SIMSBORO AQUIFER WATER DEFENSE FUND

The Simsboro Aquifer Water Defense Fund has reviewed the presentation materials for the proposed transport permits and offers the following recommendations to the Brazos Valley GCD board of directors. SAWDF urges the board to take their time to consider these permits, request additional information, and consider phasing the permits based on monitoring results and joint planning with Groundwater Management Area 12 [GMA-12].

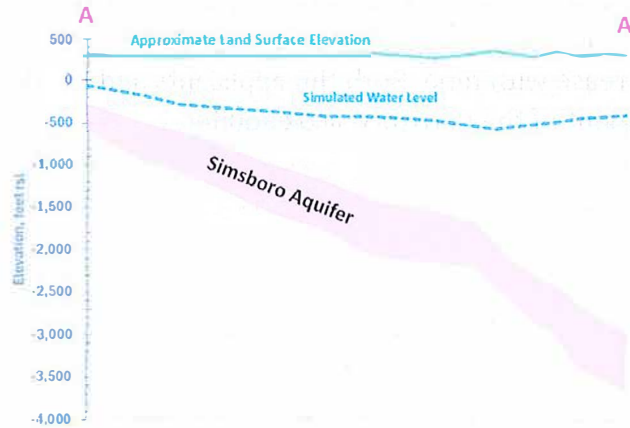
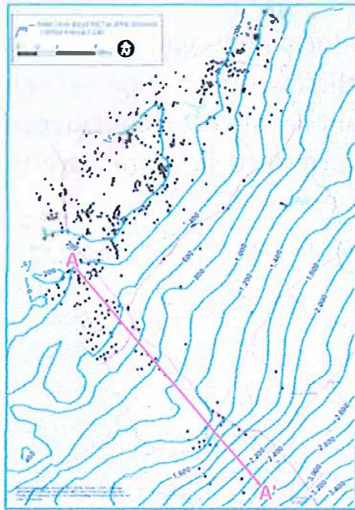
1. The remaining available drawdown in the northern half of the Simsboro will be significantly reduced and set on a declining trajectory. [See slides 9 & 10 in AGS presentation]
